Market Street Pump Station Disinfection System Upgrades
Solicitation Number: CO-00463-FG
Job No.: 21-6008

ADDENDUM 1
November 4, 2021

A
M-04 M-04
BRINE TANK AREA SECTION
SCALE: 3/8"=1'-0"

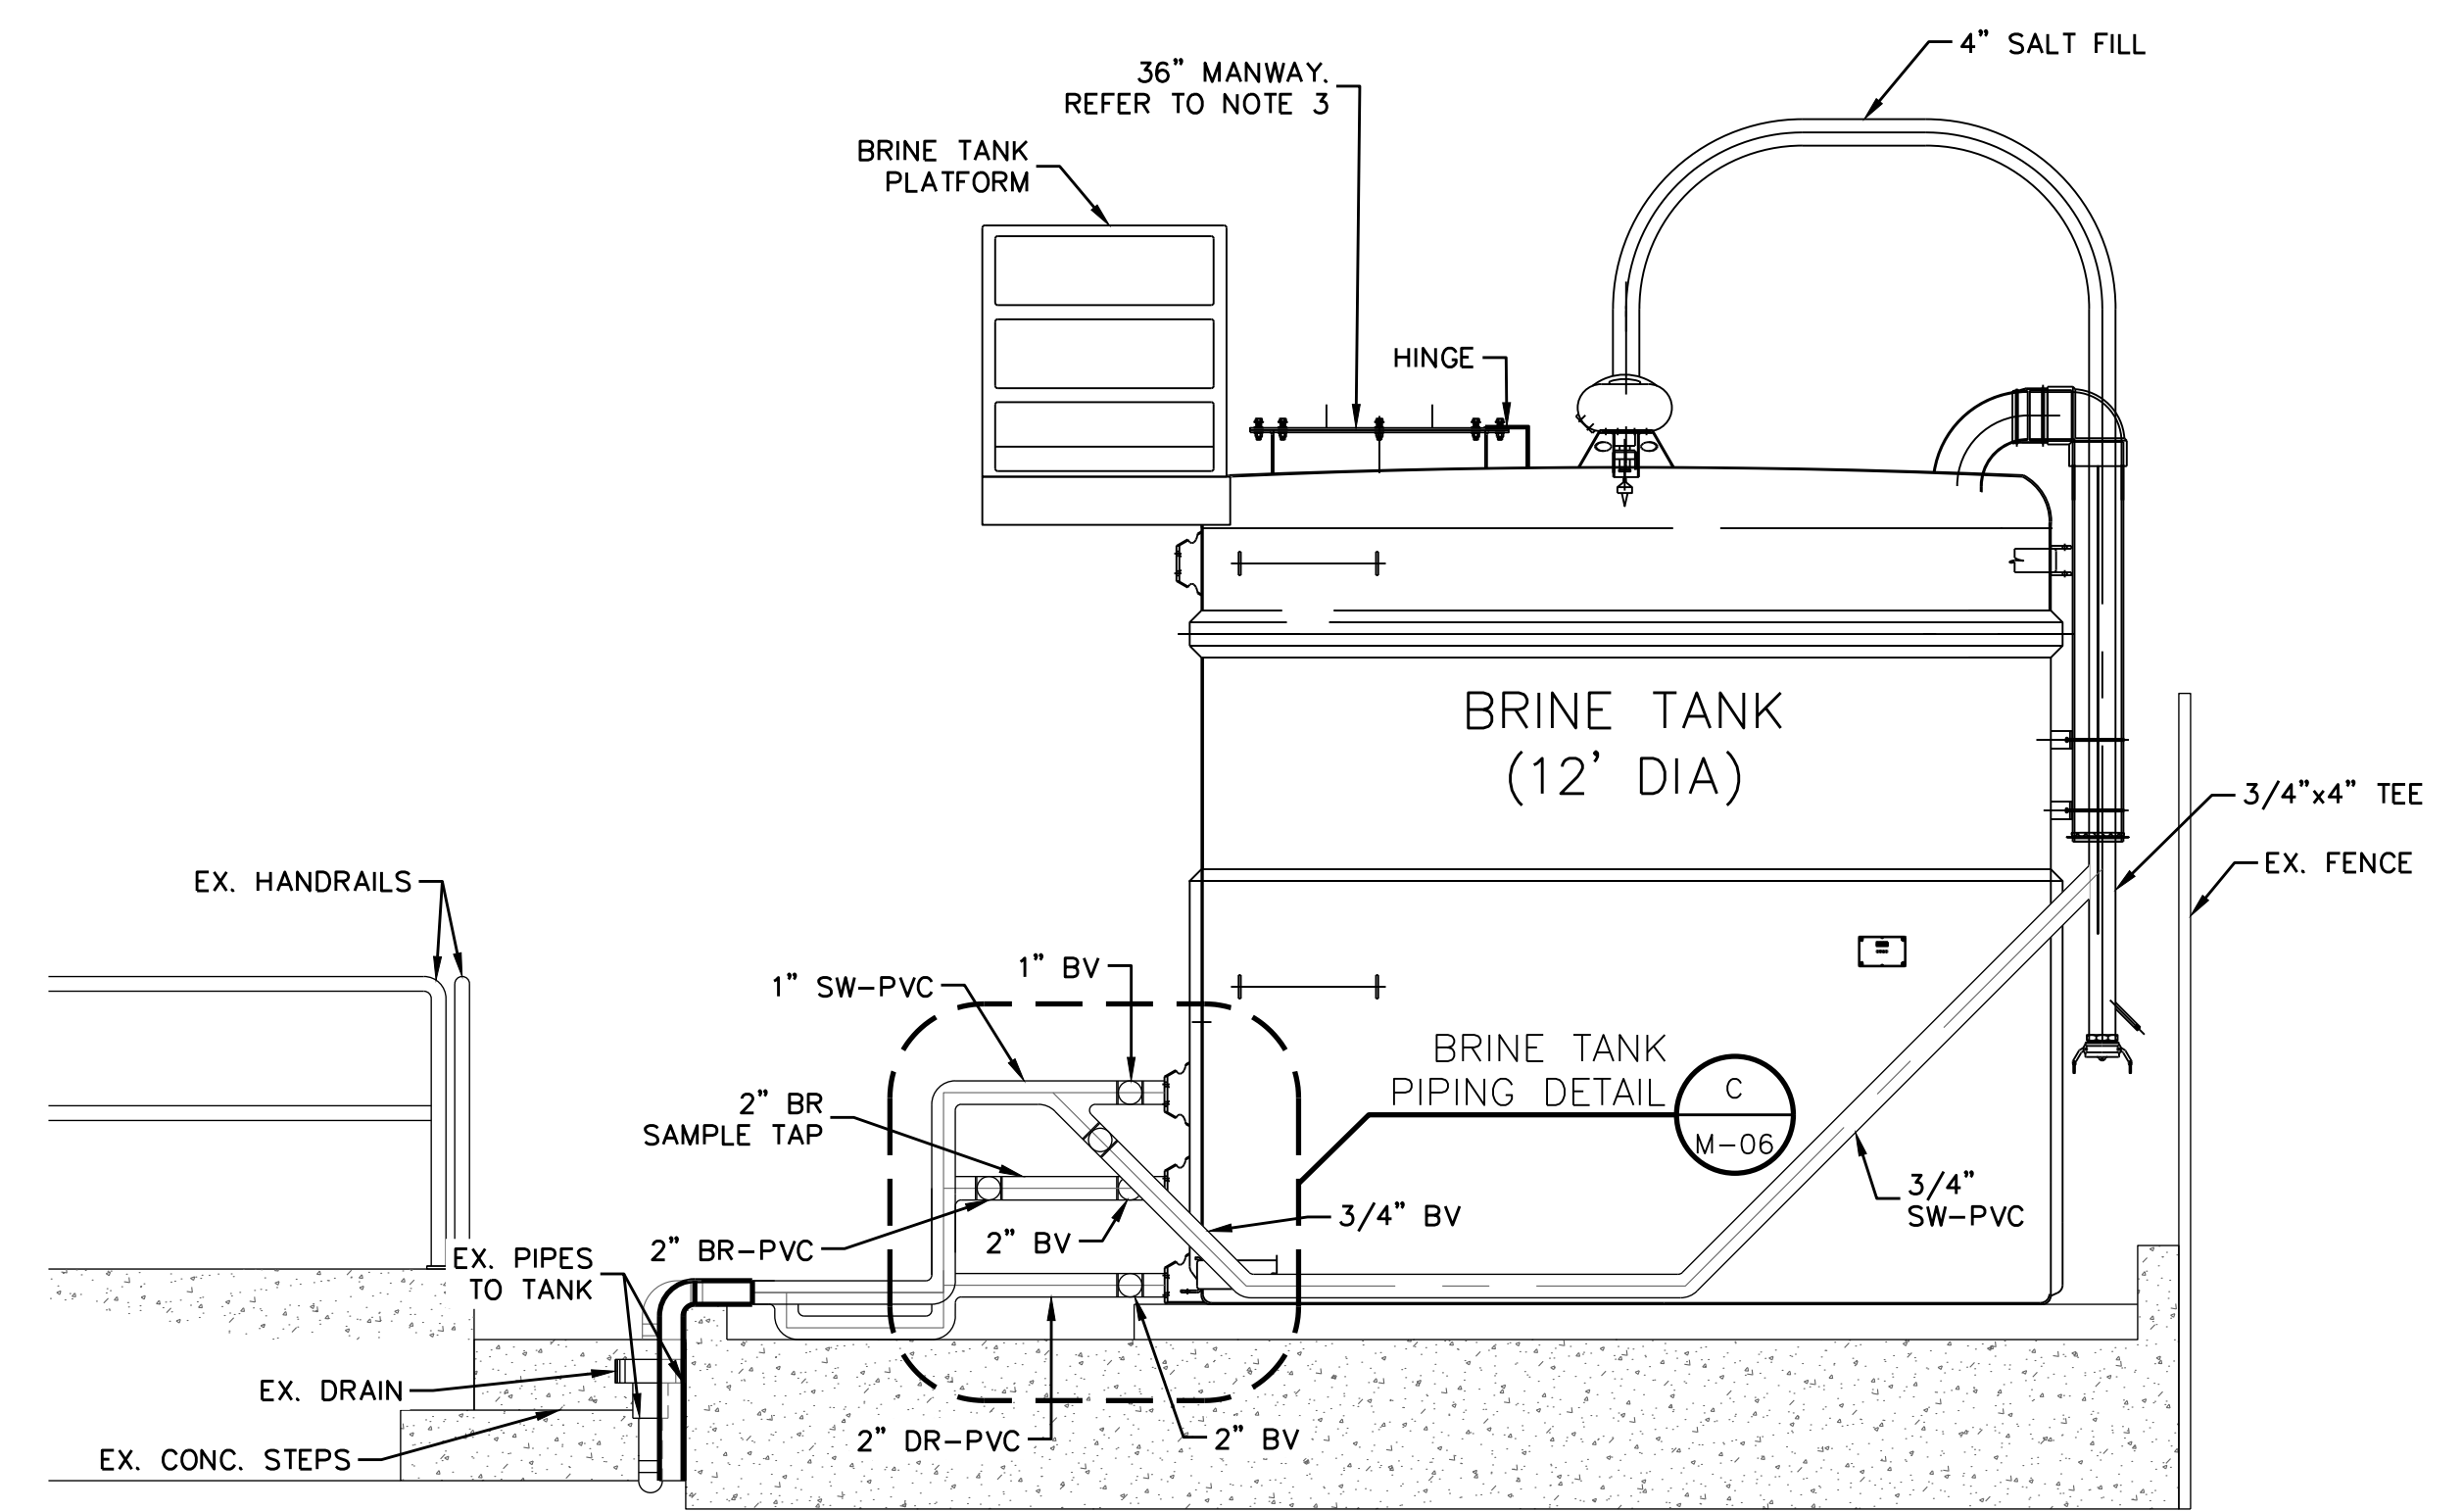
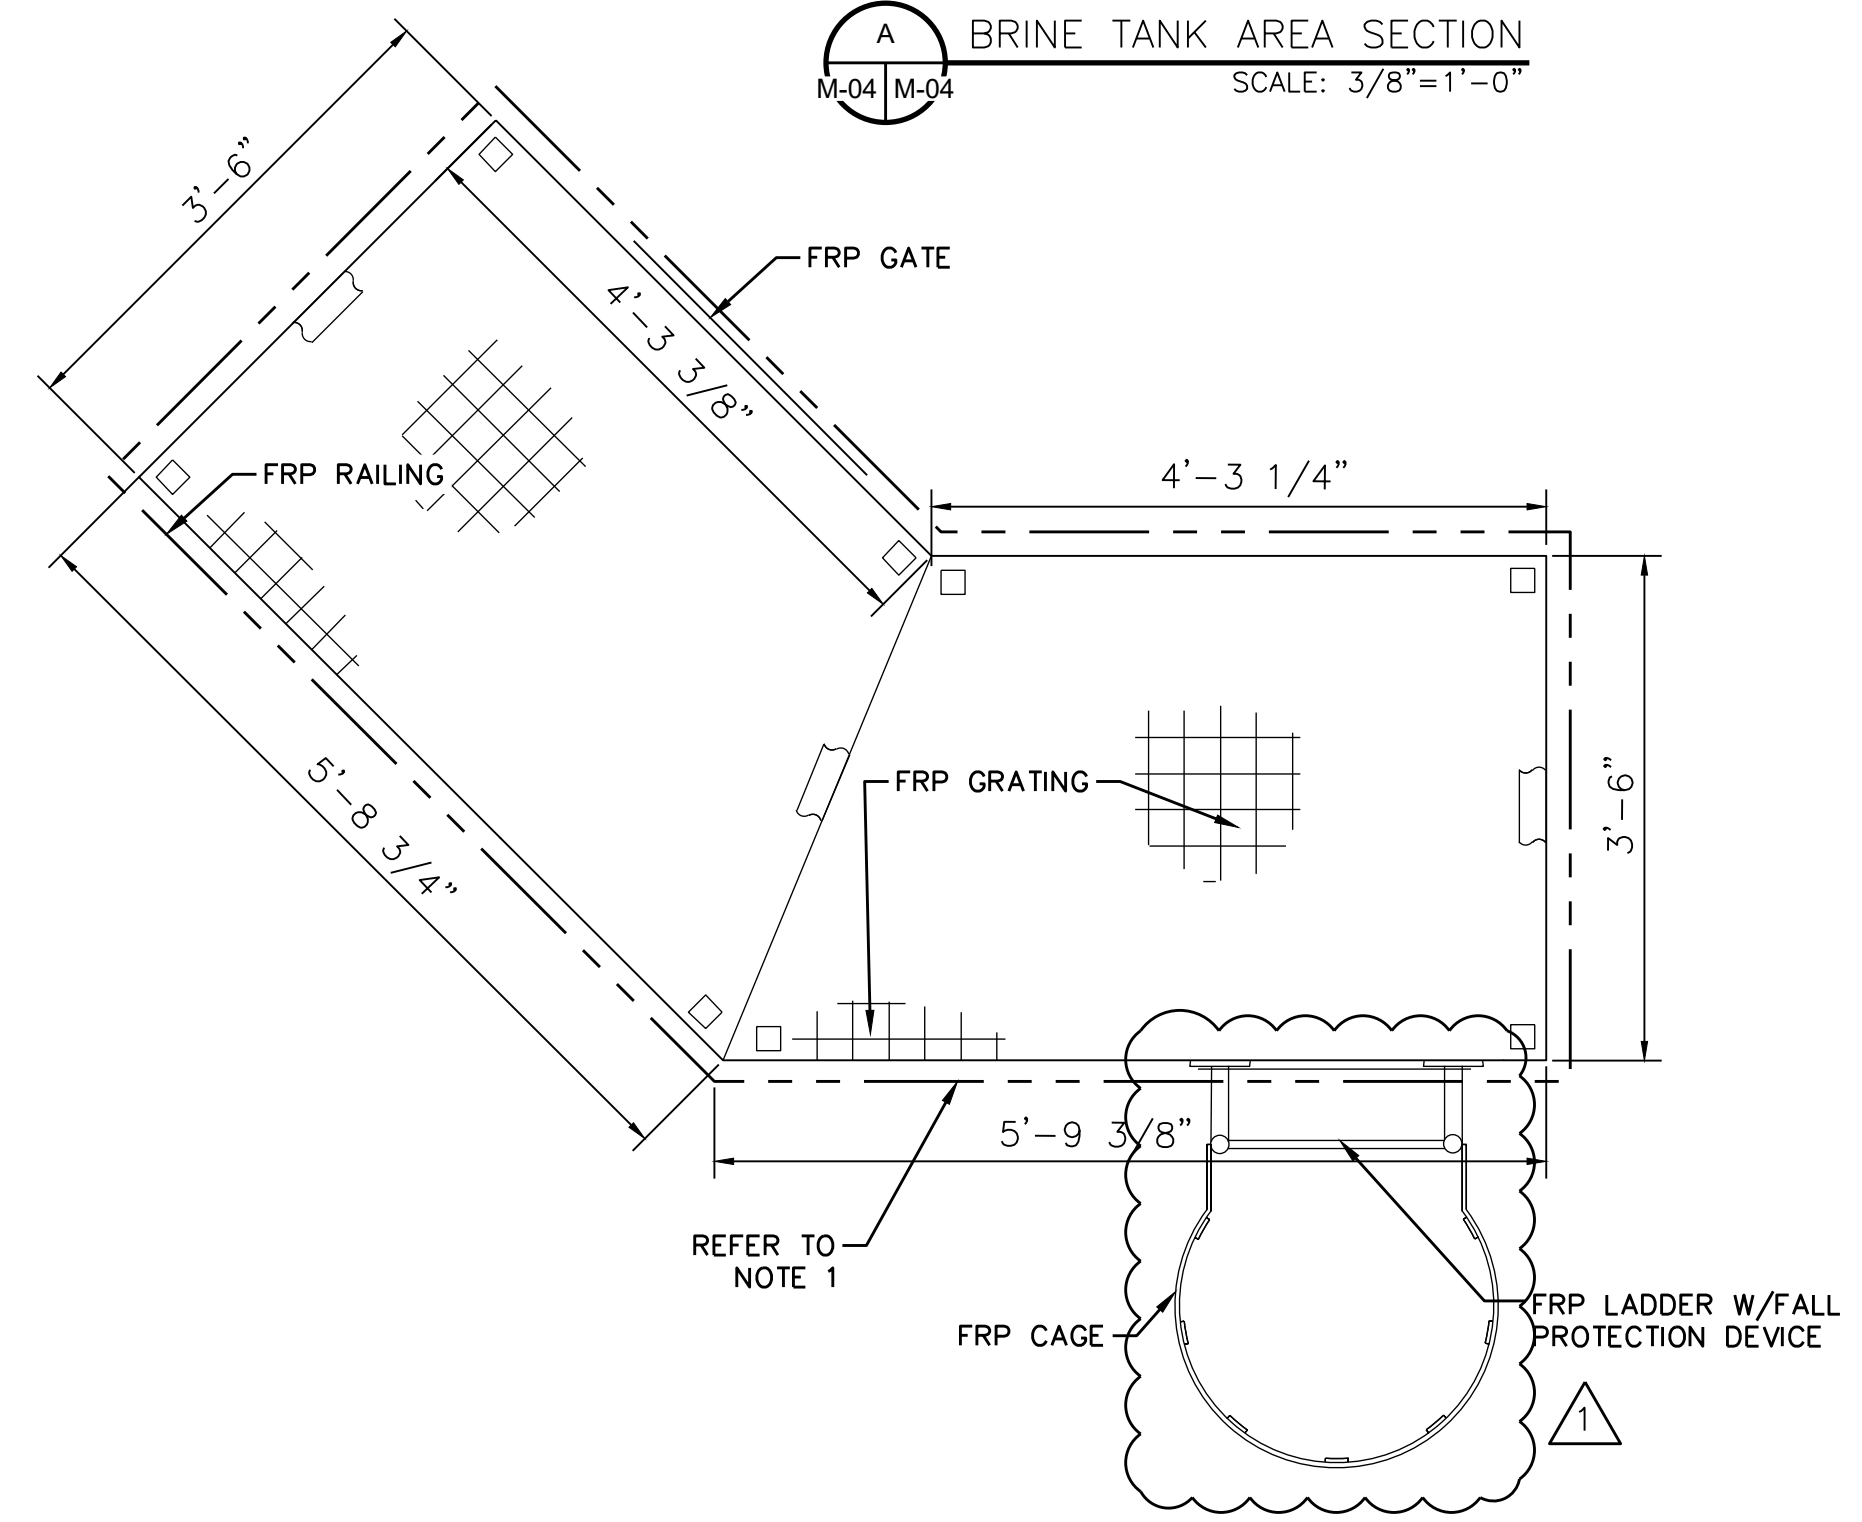
10. Question: Sheet M-04, detail A, what is the vertical pipe next to the C-M06 callout?

Response: The vertical pipe is the Liquid Level Transmitter. It has been relocated to approximate 315° location of the Brine Tank. See the "Changes to the Plans" section below. Sheet M-04 plan view and Detail A no longer show the Liquid Level Transmitter at the 180° location, but it is now in the approximate 315° location. Also Sheet E-24 is updated to reflect the Liquid Level Transmitter at approximate 315° location.

A GATE SECTION
M-04 M-06 SCALE: 1/2"=1'-0"

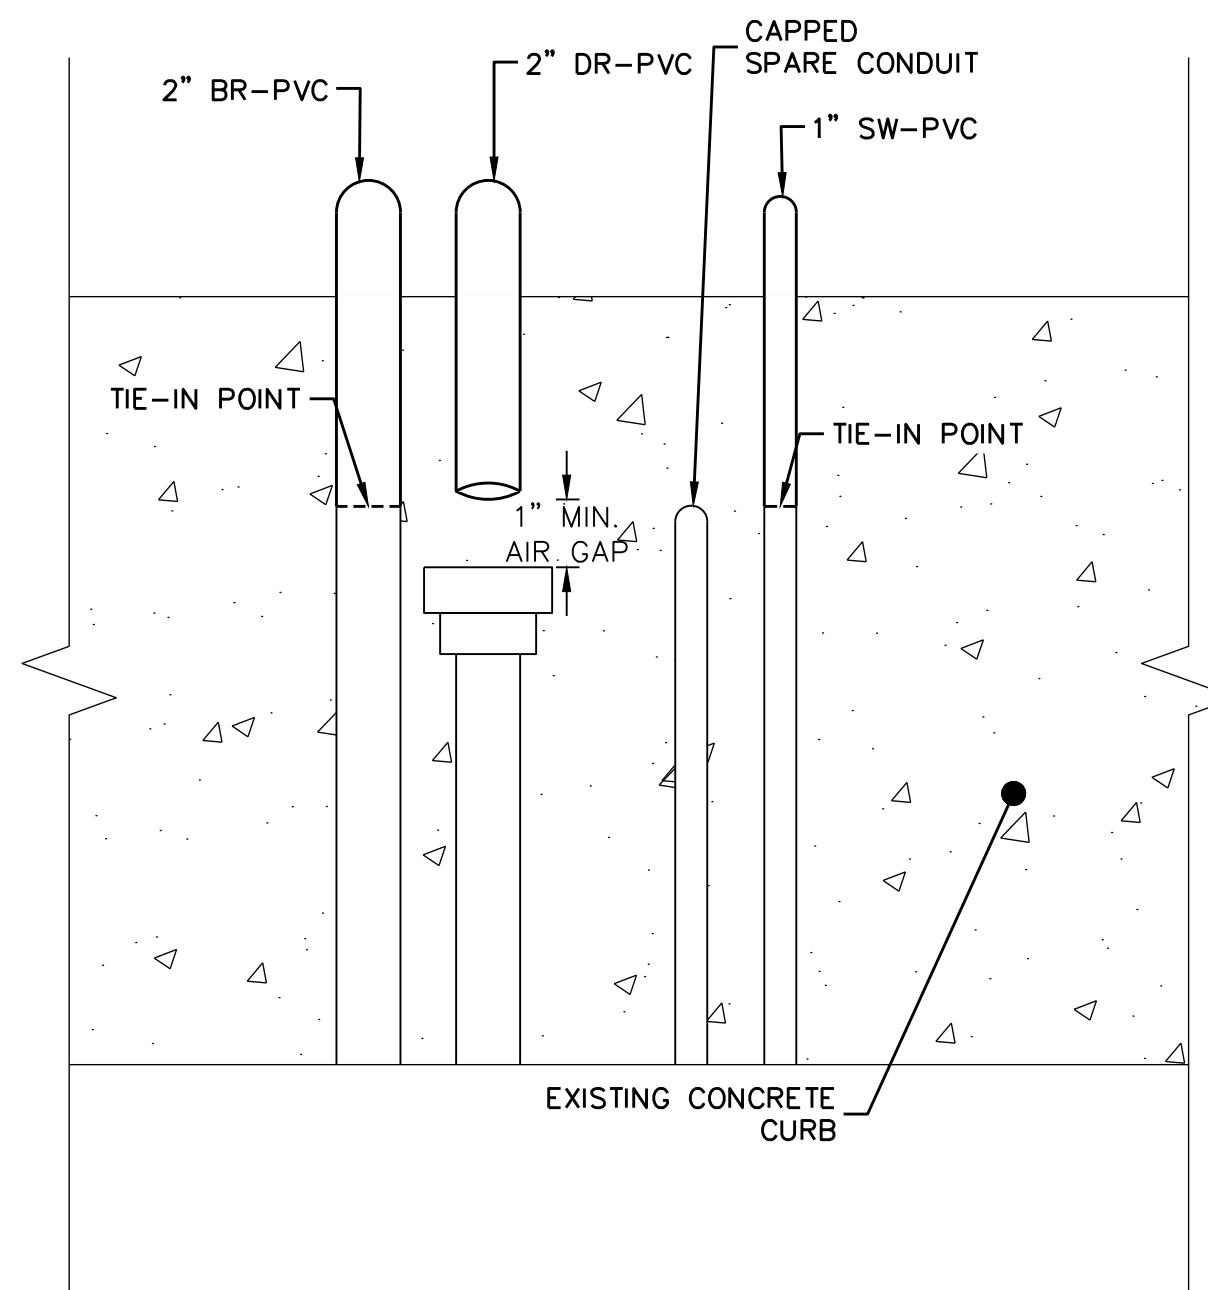
9. Question: What is the height of the existing fence where the gate is to be installed?

Response: The height of the iron fence is 8-feet. See the "Changes to the Plans" section below. Sheet M-06, Section A has the 8-foot dimension added.
